APPENDIX 8-B

Addendums for Waste, Domestic Waste and Operational Infrastructure Management Plans

8-B.3: Water Quality and Flow Monitoring Plan

| Project Name: | Meadowbank Gold Project | |

FIGURE 2-6

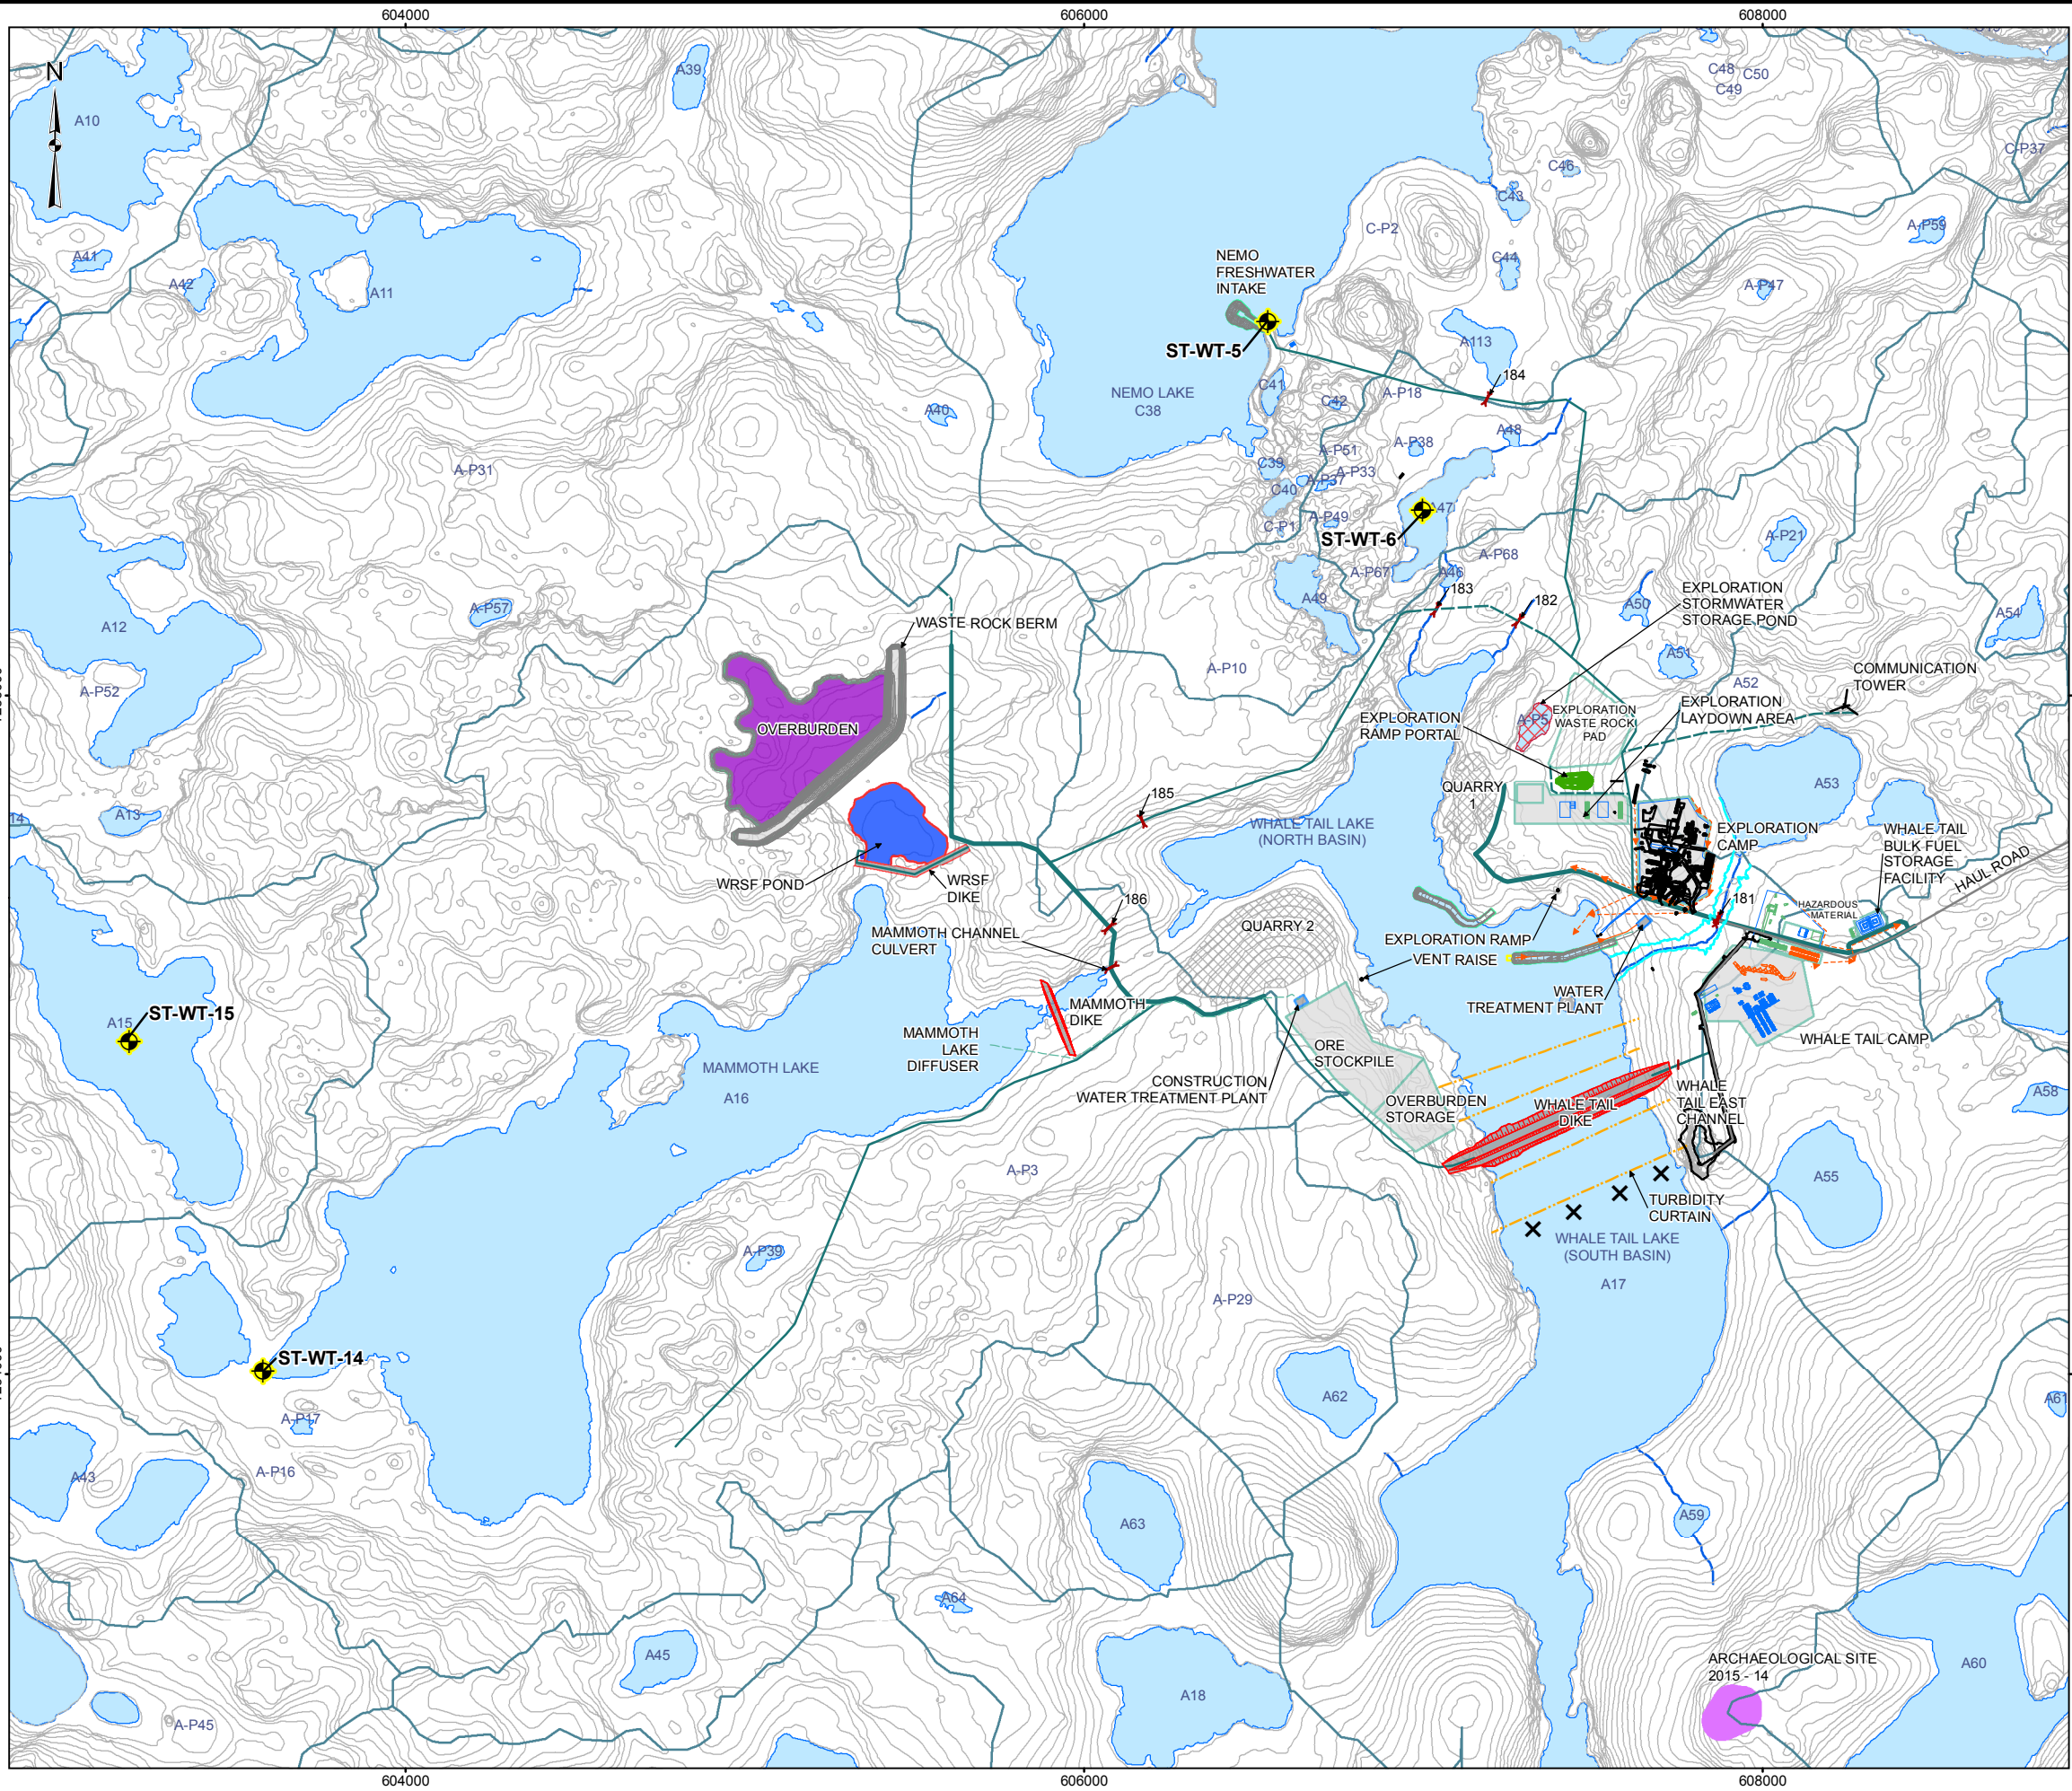
Figures 2-6, 2-7, 2-8, and 2-9 show the water quality monitoring locations by mine phase.

Figures 2-1, 2-2, 2-3, 2-4 and 2-5 show the approximate location of each of the sampling sites. **Figures 2-6 to 2-9 show the approximate location of the sampling sites at the Whale Tail Pit area.** The actual location of each sampling site is determined by access and safety considerations and are marked by a stake that defines the exact location of the collection point for sampling events with appropriate attached signage in English, Inuktitut and French.
